Request for Further Information – Burnham 2020 Ltd - RC235522

RESPONSE TO SDC RFI - NOISE

**RE: Burnham Quarry
S92 response - Selwyn District Council Request for Information**

Figure 2-1: Strava Cycling Heat Map (December 2023)

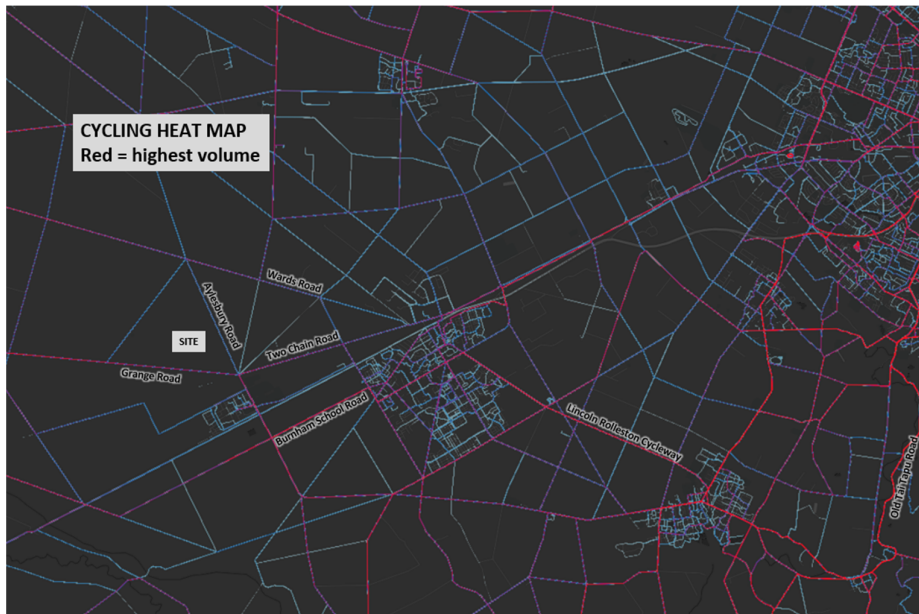
- (ii) Question: Table 4-2 of the ITA sets out pedestrian and cyclist numbers. Please confirm what day of the week these were undertaken. If they were undertaken during a weekday, please comment on the potential for Aylesbury Road to be used by recreational cycling groups during the weekend, and whether any further assessment is required to account for these.

Formal observation on weekends has not been carried out. The activity tracking app Strava provides a "Global Heatmap" broadly showing the relative dominance of routes (with no day to day distinction). The bicycle heatmap (Figure 2-1) shows that Aylesbury Road north of Two Chain Road has a comparatively low use when considered against well-known recreational cycling routes and routes with offroad paths, such as the Old Tai Tapu Road, and Rolleston-Lincoln route.

No further assessment is proposed of Aylesbury Road in respect of weekend use by cyclists and pedestrians for the following reasons:

- the activity will be accessing an arterial road (that by definition is anticipated to accommodate higher volumes of through traffic),
- the road does not form part of an identified cycle or walking network, and is not highlighted as an important recreational route in the heatmap,
- weekday counts show low levels of pedestrian and cycle activity, and
- the quarry activity will generally generate lower levels of traffic on a weekend.

Figure 4-1: Christchurch Focus Warrant Diagram

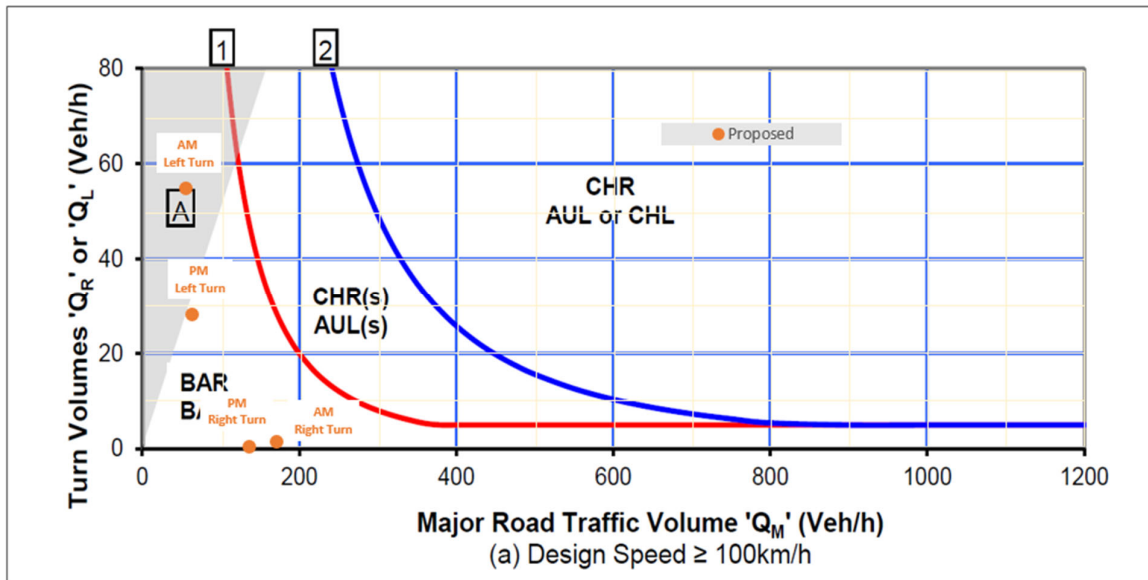
- (iv) Question: Figure 10-1 does not suggest that auxiliary turning lanes will be provided at the site access. Please provide an assessment of the warrants for auxiliary turning lanes, taking into account the proportion of heavy vehicles as appropriate.

In order to consider the need for turn lanes at a standard priority intersection, reference has been made to the Austroads "Guide to Traffic Management Part 6 Intersections Interchanges and Crossings Management" Section 3.3.6 warrants for turn lanes. The appropriate turning treatment depends on a combination of speed, and volumes of through traffic and turning movements. Analysis has been undertaken for both a Christchurch City (Figure 4-1) and Selwyn District (Figure 4-2) traffic distribution focus as included in the ITA. The resulting combinations of traffic volumes are plotted on the graphs below.

As can be seen, under both the Selwyn and Christchurch focus traffic distribution scenarios, basic right-turn treatments and basic left-turn treatments will be warranted. This indicates that a simple layout which satisfies the requirements of rural basic turns is required.

Given the low traffic volume of the road, the increase in heavy vehicle traffic does not warrant auxiliary turning lanes at the site entrance.
